CITY OF DUBLIN

## PLANNING REPORT

1. **NE Quad – Subarea 2 – Emerald Fields Park      4040 Wyandotte Woods Boulevard**  
**09-030AFDP      Amended Final Development Plan**

Proposal: To construct a restroom and maintenance building and to install a universally accessible playground, parking lot, shelter, and landscaping at the Emerald Fields Park located on the north side of Wyandotte Woods Boulevard, approximately 1,000 feet northwest of the intersection with Emerald Parkway.

# PROPOSED SITE PLAN

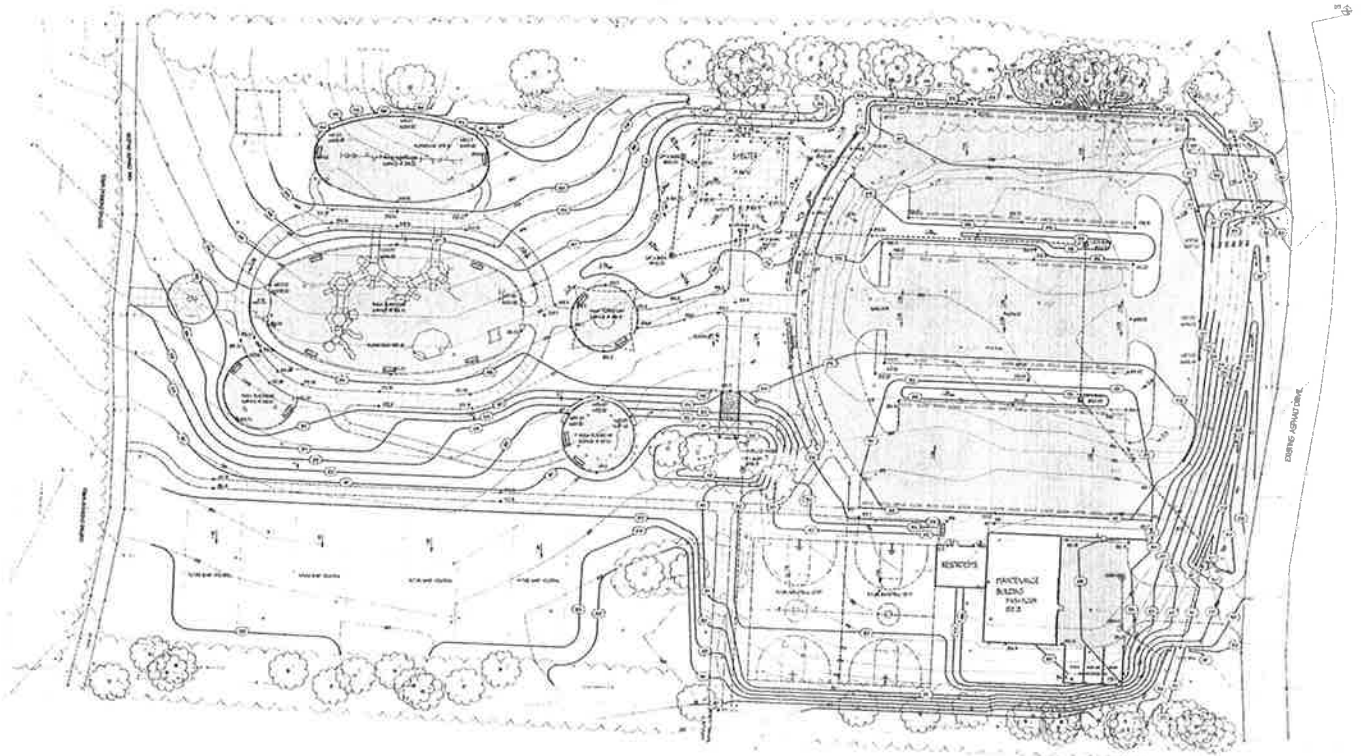
The proposed plan meets the required interior landscape area for vehicular use area with the use of the two large landscape islands and trees within the interior of the proposed parking lot. Code also requires screening for the vehicular use perimeter buffering. Planning recommends the use of mounding and plant material along the eastern side of the existing private drive, consistent with the screening used for the northern area of the park.

**Criteria are met with condition:** The proposed improvements conform to the Master Plan for this park. In order to ensure appropriate water and sewer facilities are provided to the site a final utility plan will be required as part of the building permit approval (Condition 1). Code requires screening for the vehicular use perimeter buffering and in order to meet this requirement Planning recommends the use of mounding and plant material along the eastern side of the existing private drive, consistent with the screening used for the northern area of the park (Condition 2). All other applicable zoning requirements have been satisfied.

- 1) A final utility plan is required as part of the building permit approval indicating appropriate water and sewer connections to the site.
- 2) Utilize mounding and plant material along the eastern side of the existing private drive to meet the vehicular use perimeter buffering requirements, subject to Planning approval.
- 3) Wood lattice shall be substituted for the proposed vinyl lattice screen used along the western edge of the parking lot and for screening the service area.

# PROPOSED SCREENING DETAIL

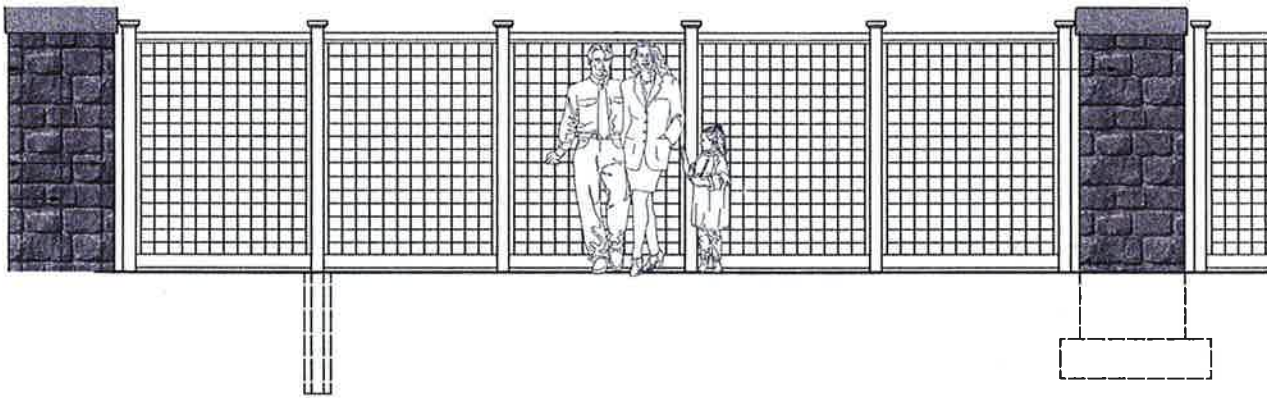
The plans indicate a six-foot tall vinyl lattice screen with stone columns separating the parking lot from the playground area. Planning recommends the use of wood material in lieu of the vinyl to complement the building materials used in the proposed park.

**Criteria are met with conditions:** The proposed improvements are sensitive to the existing conditions of the site and preserve the existing vegetation. Any existing trees that are removed as part of the site improvements will be required to be mitigated. Planning recommends the substitution of the vinyl lattice for wood lattice screen used along the western edge of the parking lot and to screen the service area (Condition 3).
